CITY OF NORTH OAKS

**Regular City Council Meeting
Thursday, July 08, 2021
7 PM, Via Teleconference or Other Electronic Means Only
MEETING AGENDA**

9b. Consider approval of application for final plan/plat/subdivision for the Island Field Development Site (Site H of the 1999 East Oaks PDA legally described as Tract D, REGISTERED LAND SURVEY NO. 561, RAMSEY COUNTY, MINNESOTA), and associated JPA for water and sewer services with White Bear Township

| PROJECT: ISLAND FIELD | SHEET DESCRIPTION: FINAL PLAT PLAN | DATE: MARCH 19, 2021 | SHEET 2 OF 8 SHEETS |

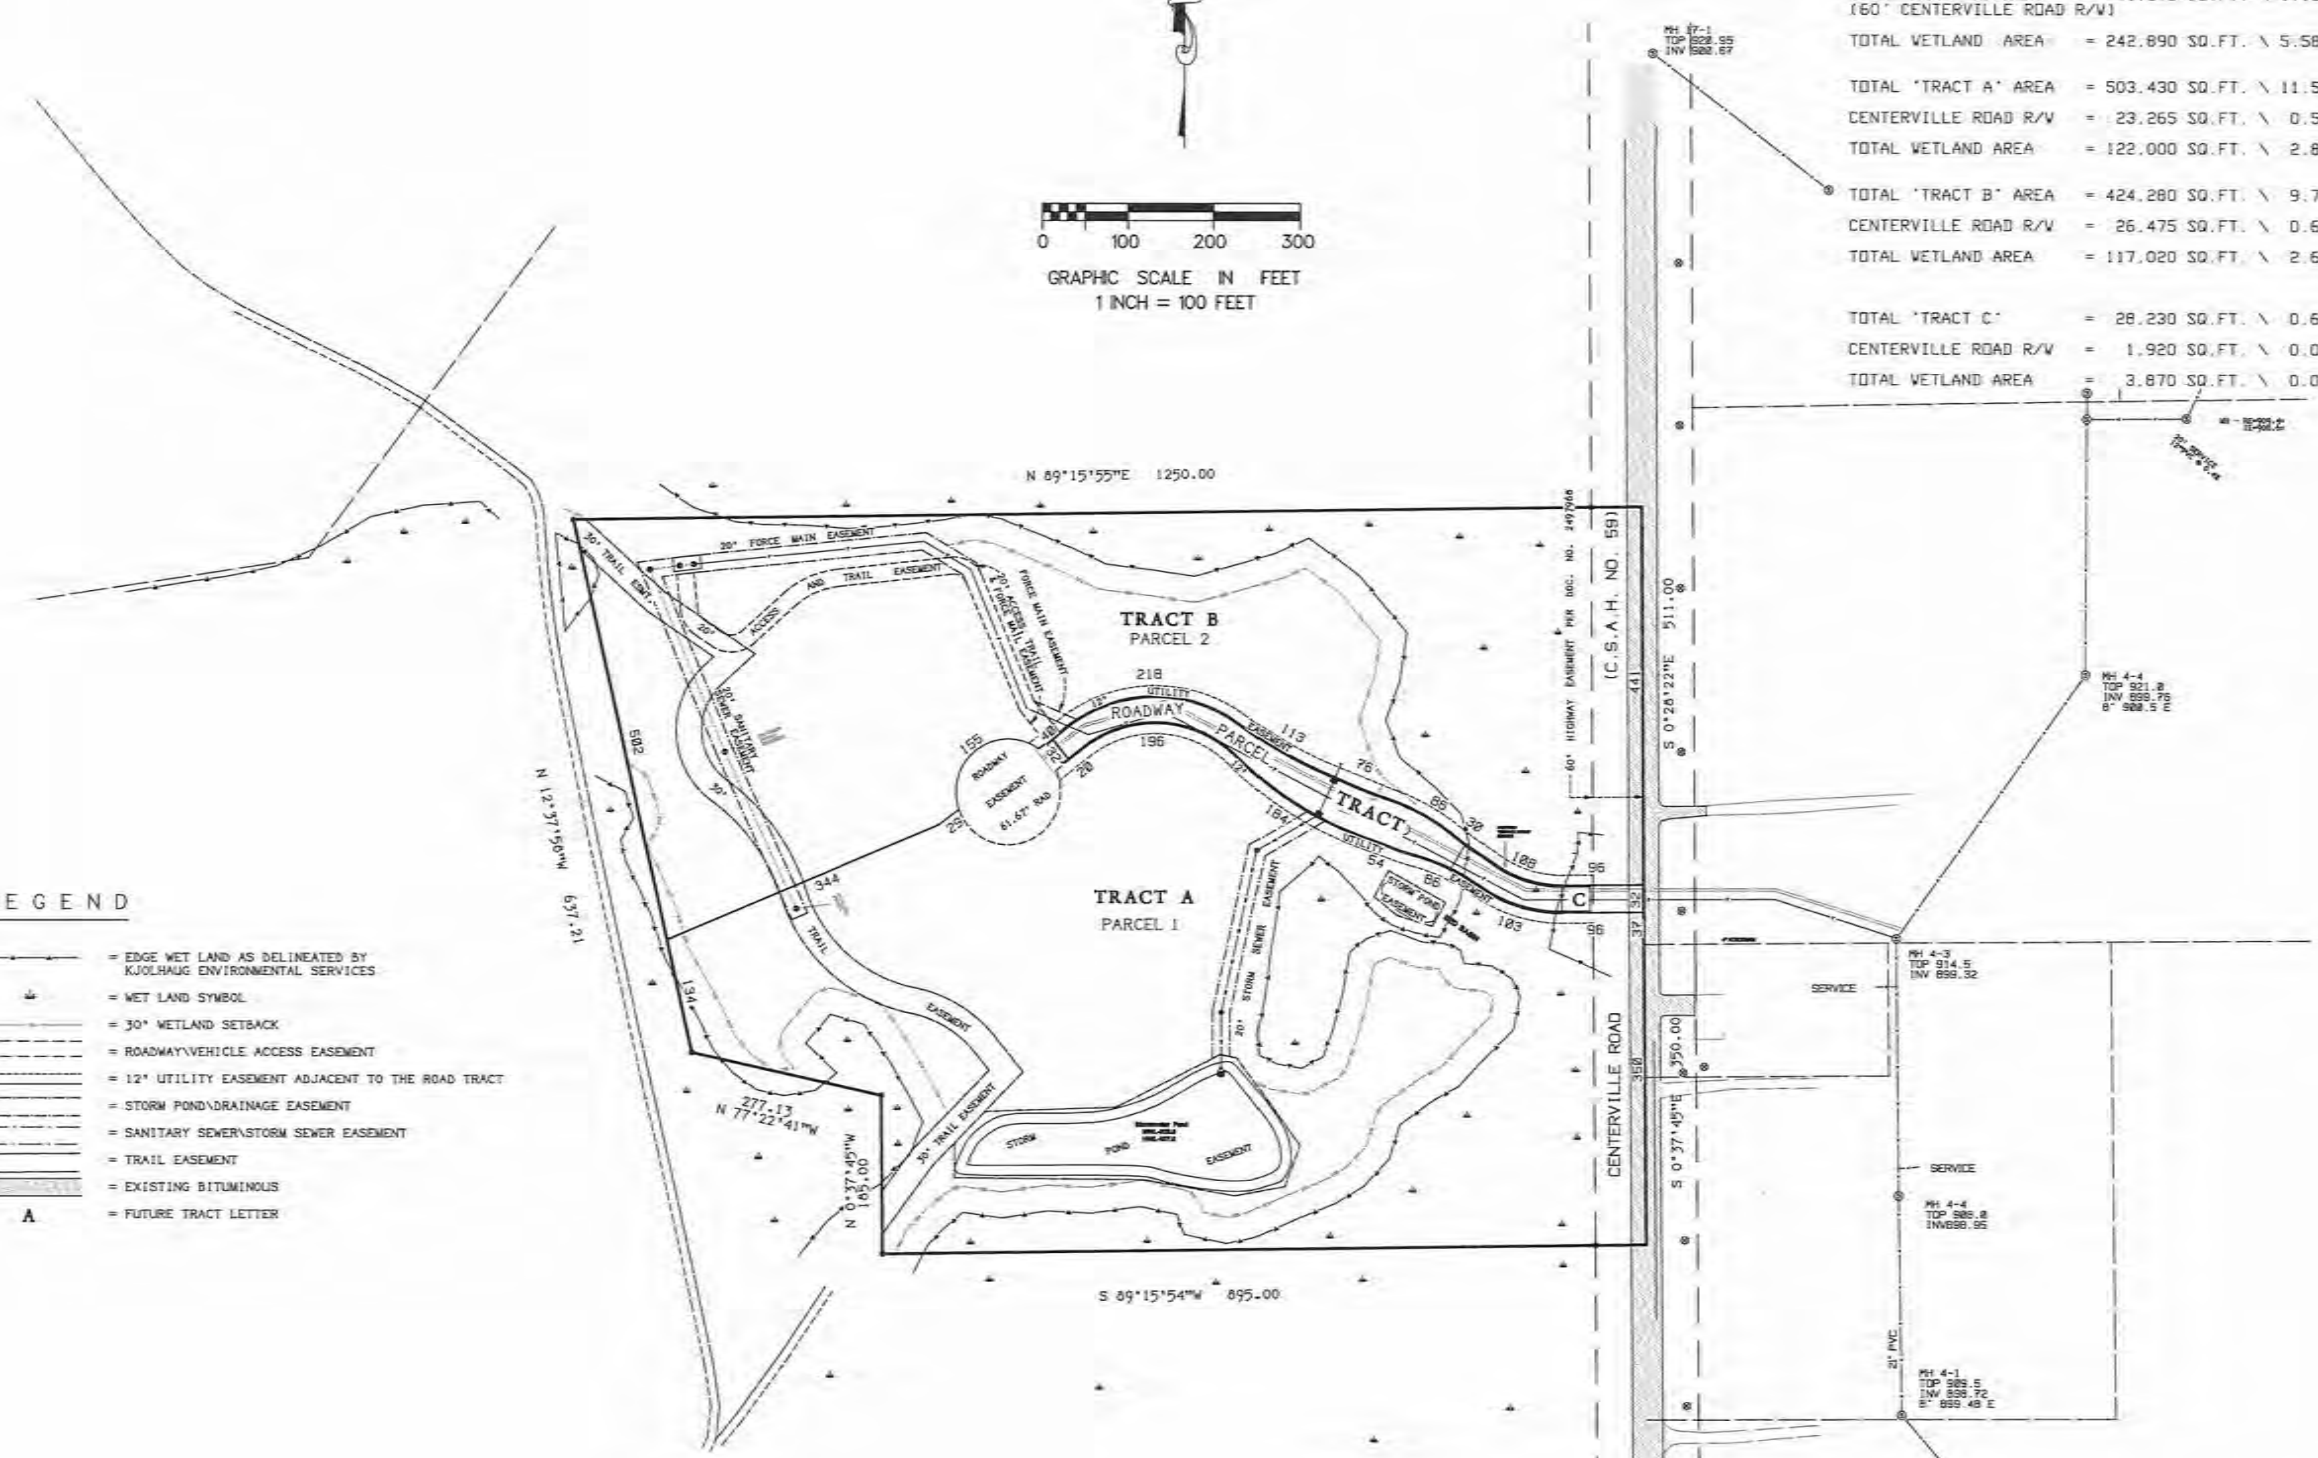
SHEET 2.0 – IF Final Plat Plan (2)

| SHEET DESCRIPTION FINAL PLAT EASEMENT PLAN | PROJECT: ISLAND FIELD | DATE: MARCH 19, 2021 SHEET 3 OF 8 SHEETS |

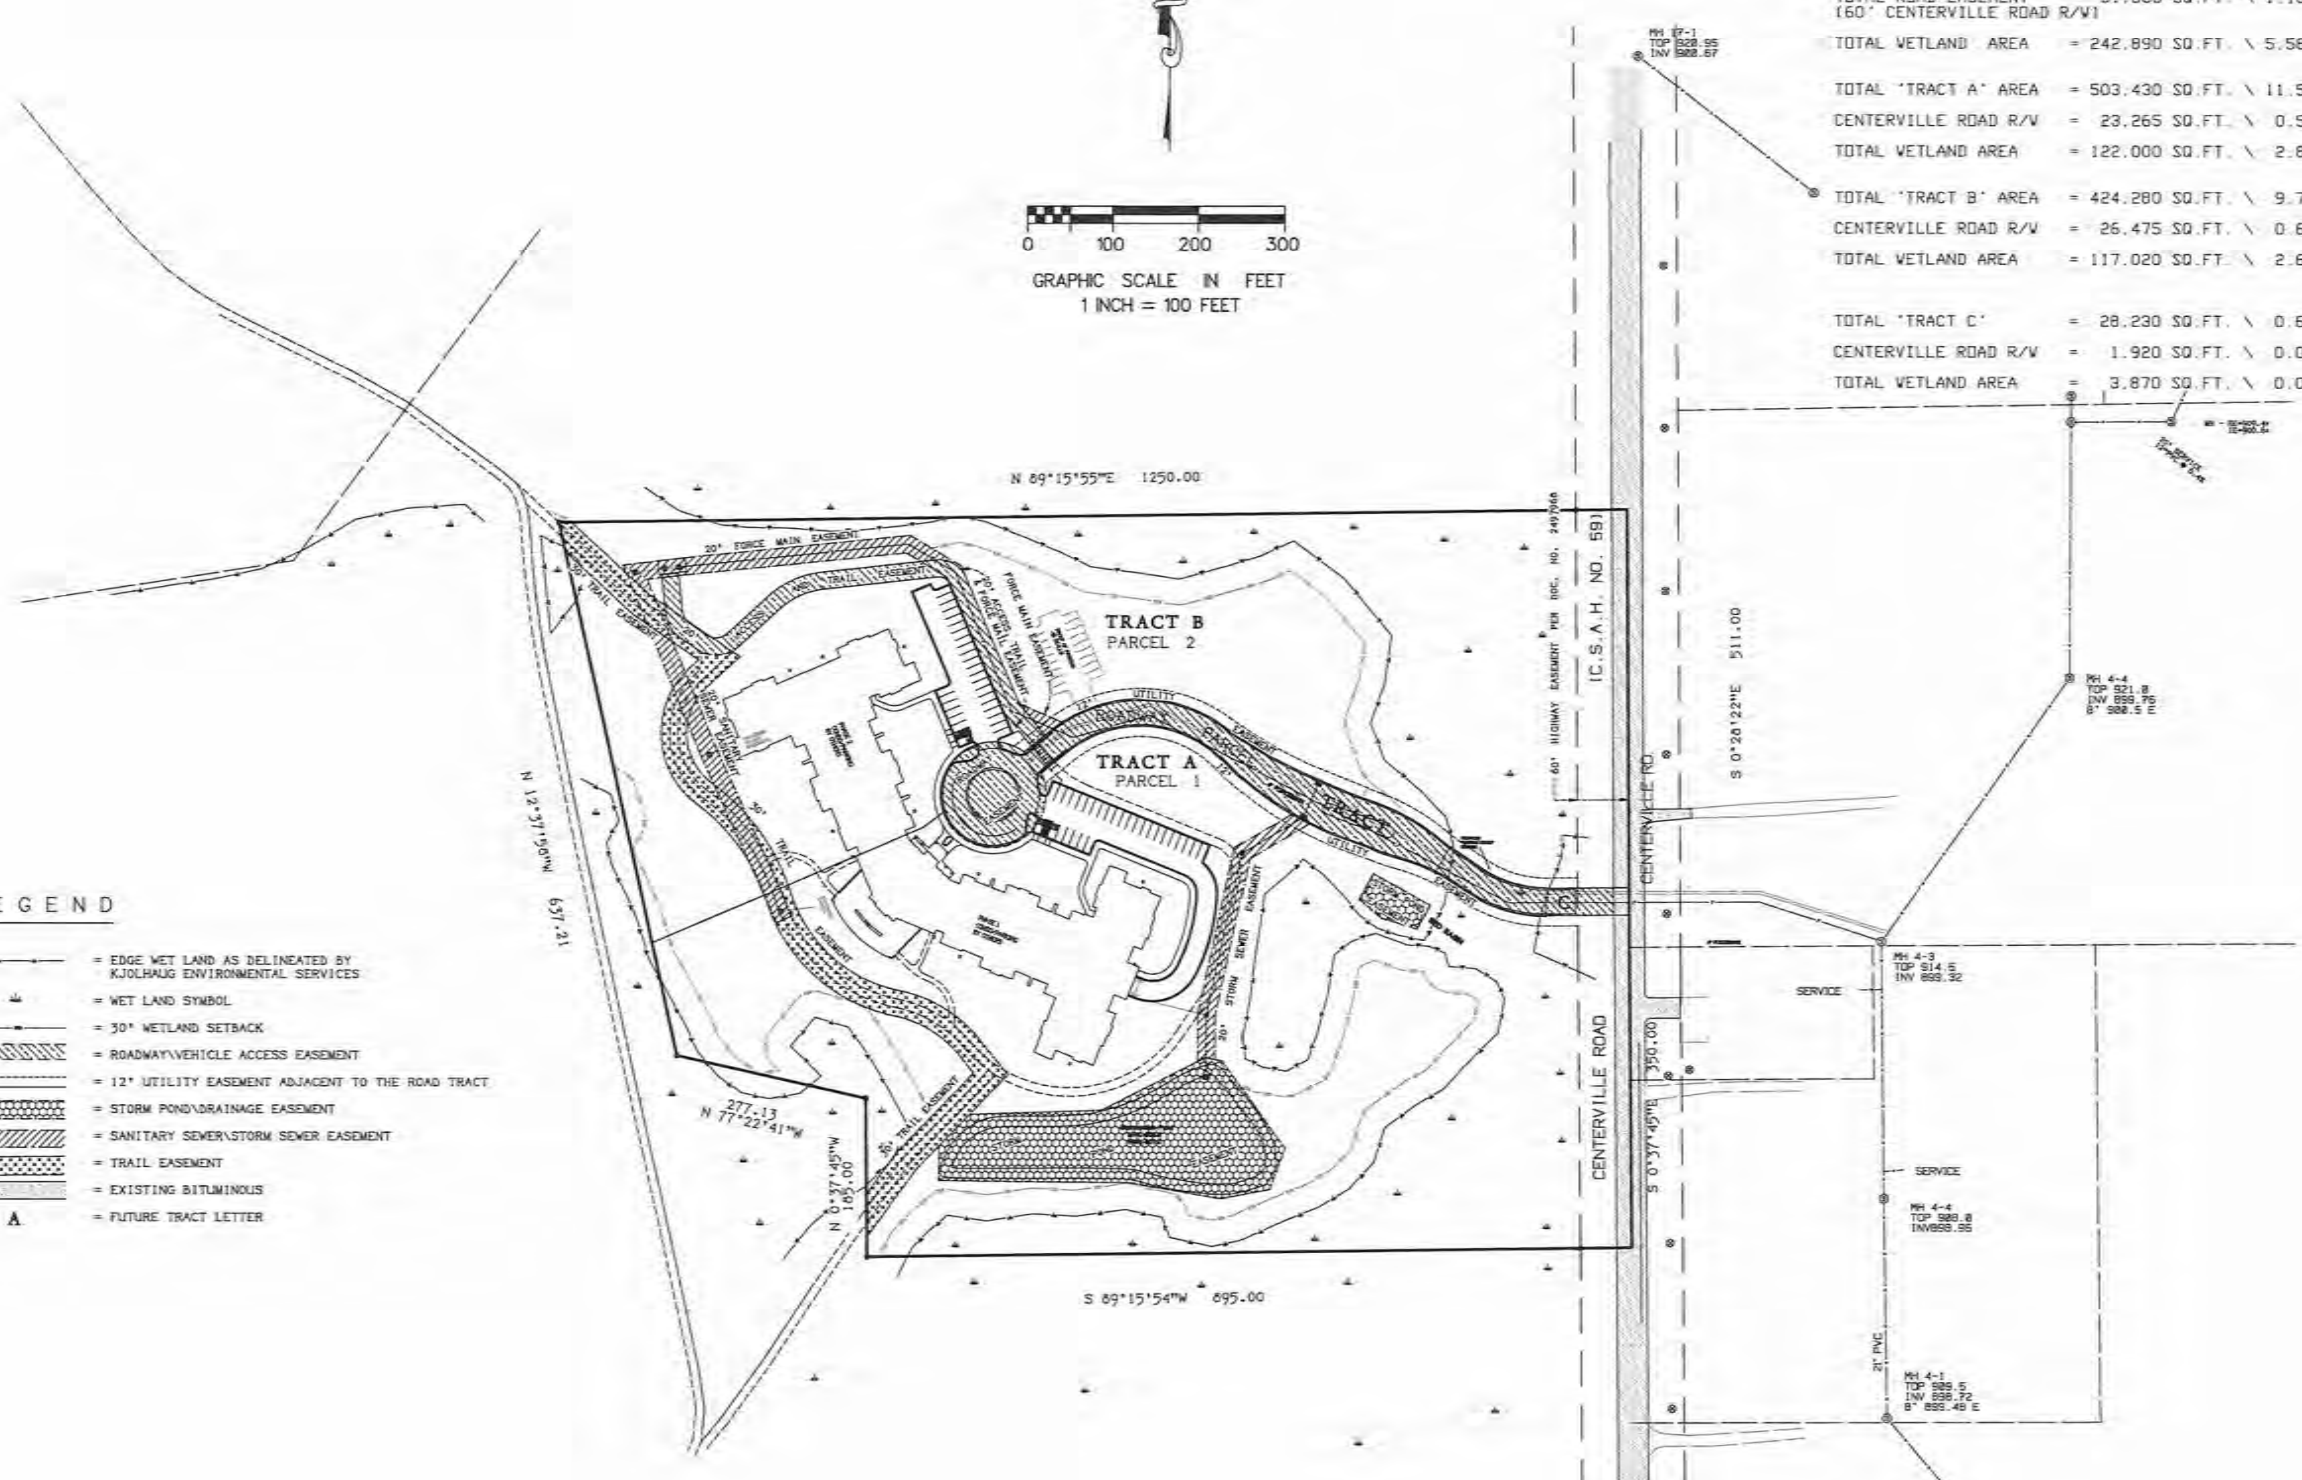
SHEET 3.0 – IF Final ESMT Plan (2)

Exhibit J: Final Grading and Erosion Plan

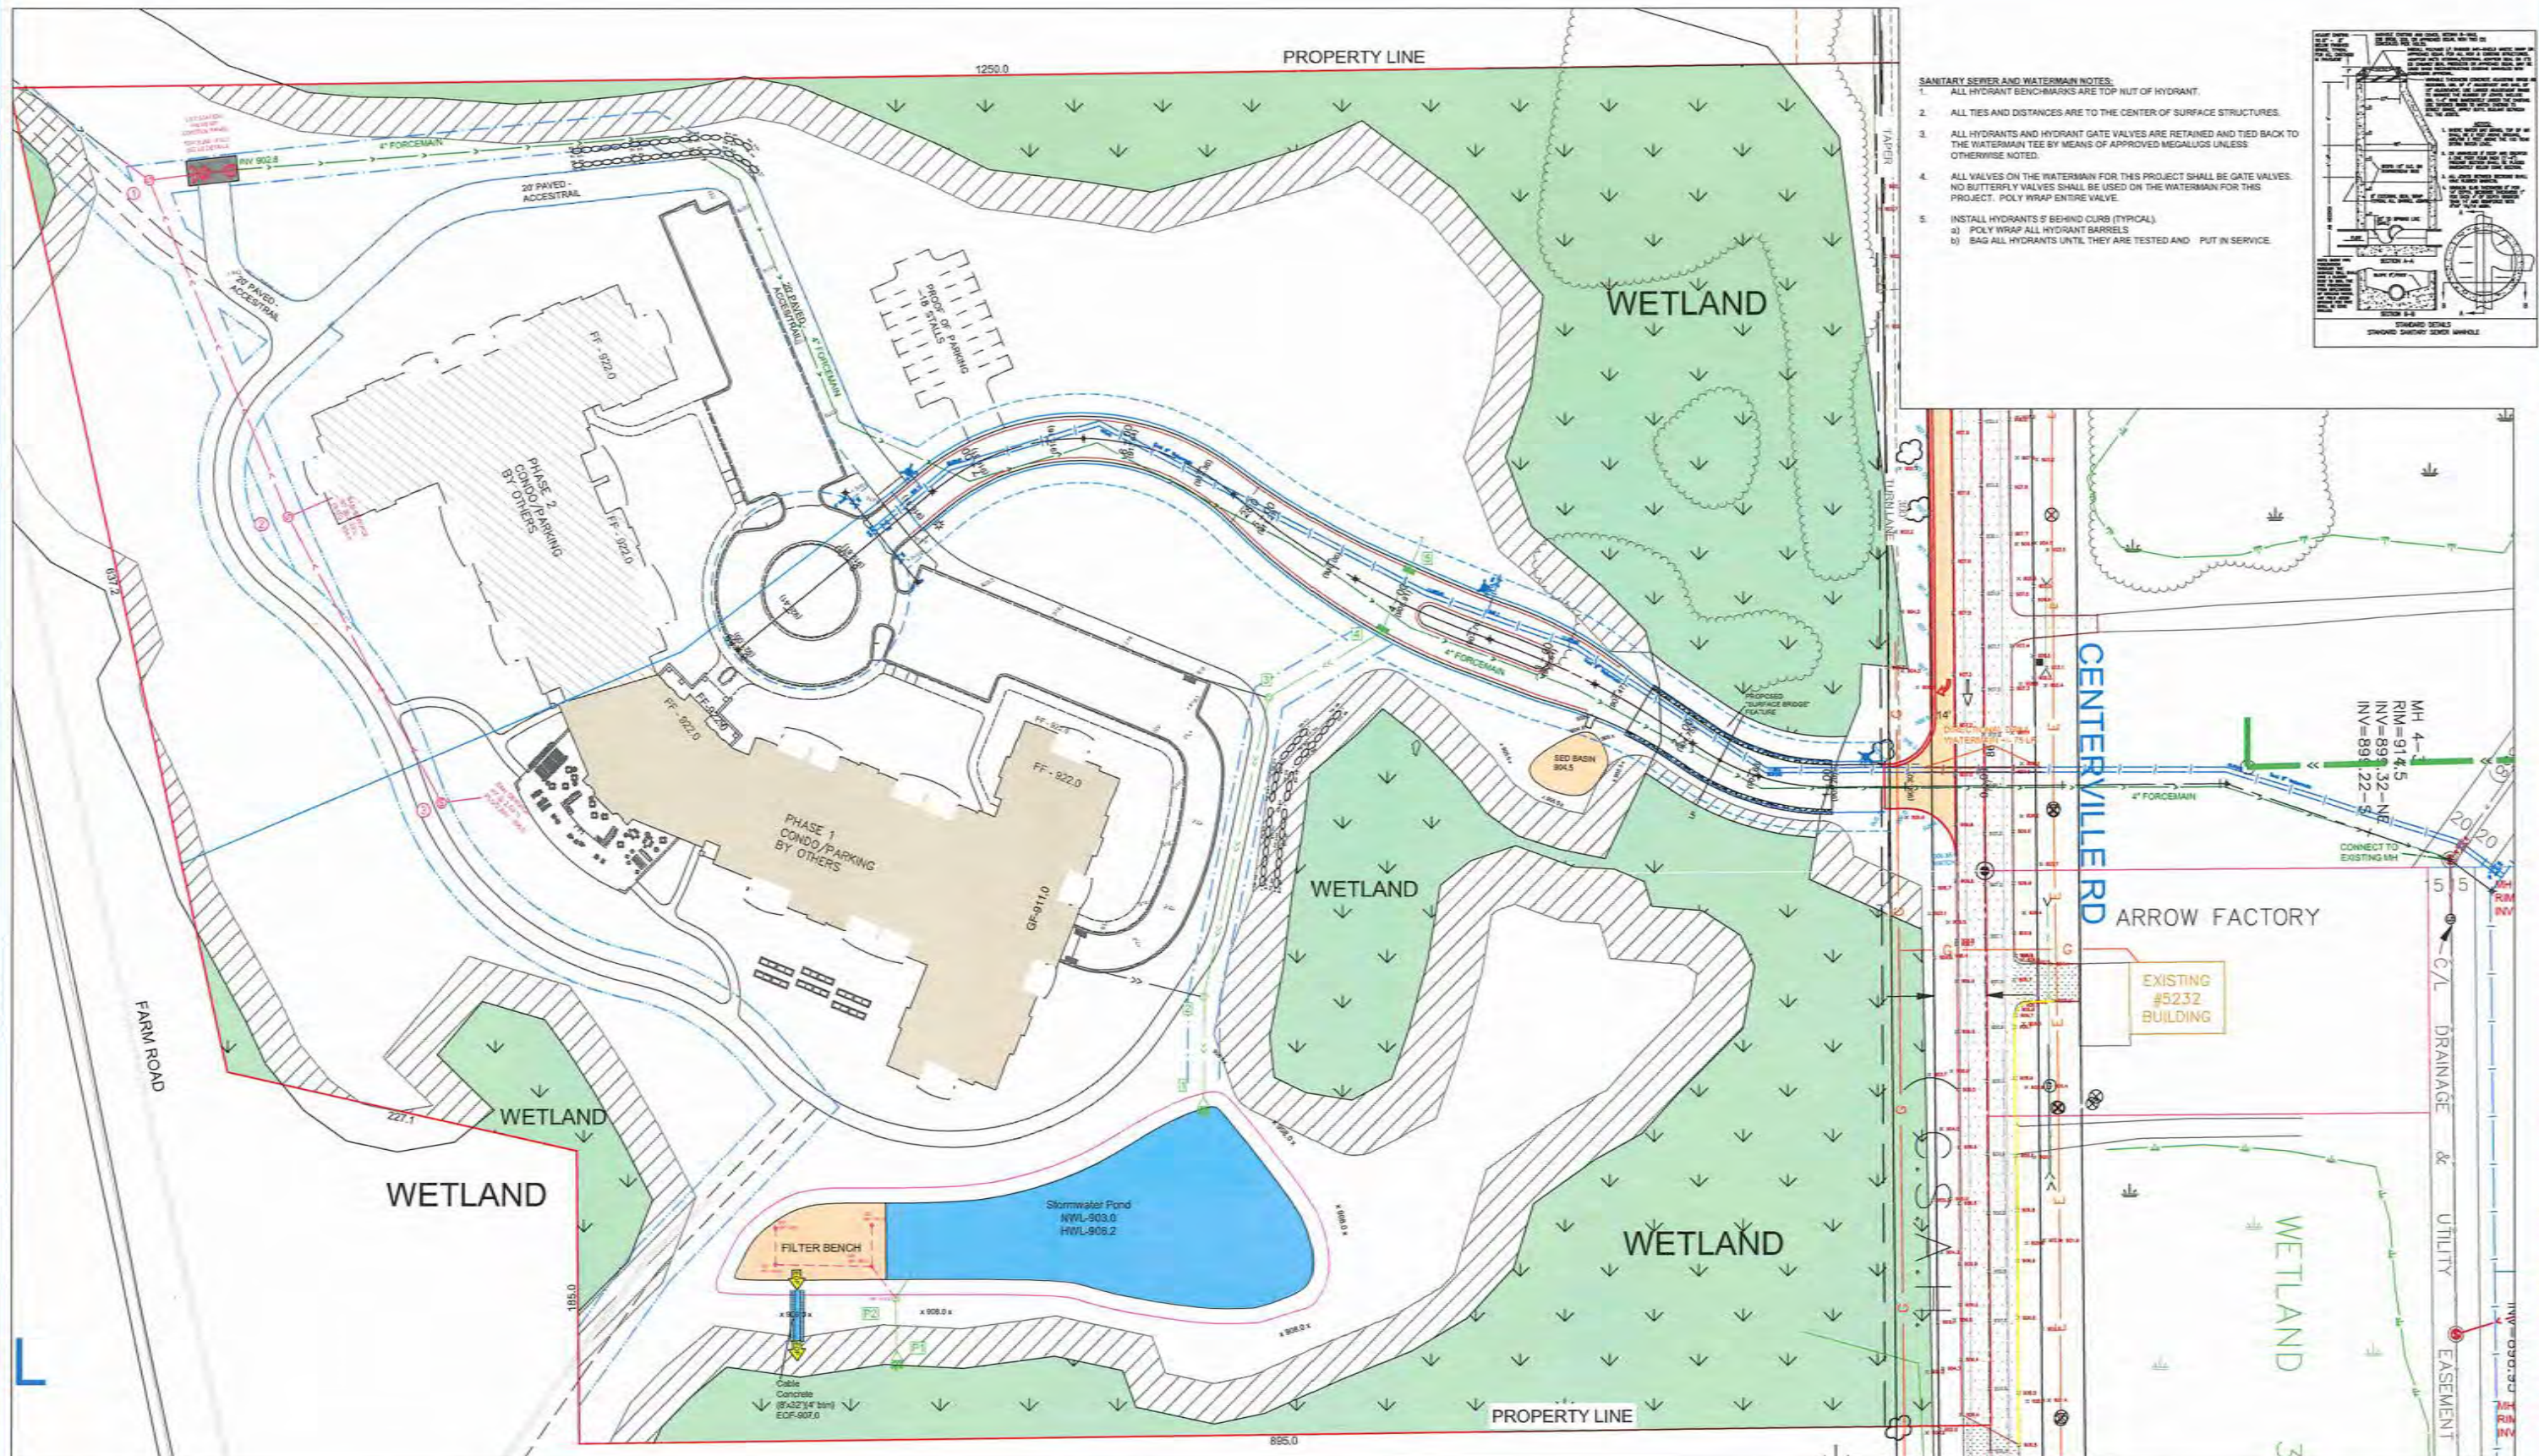
SHEET 4.0 – IF Grading Plan (2)
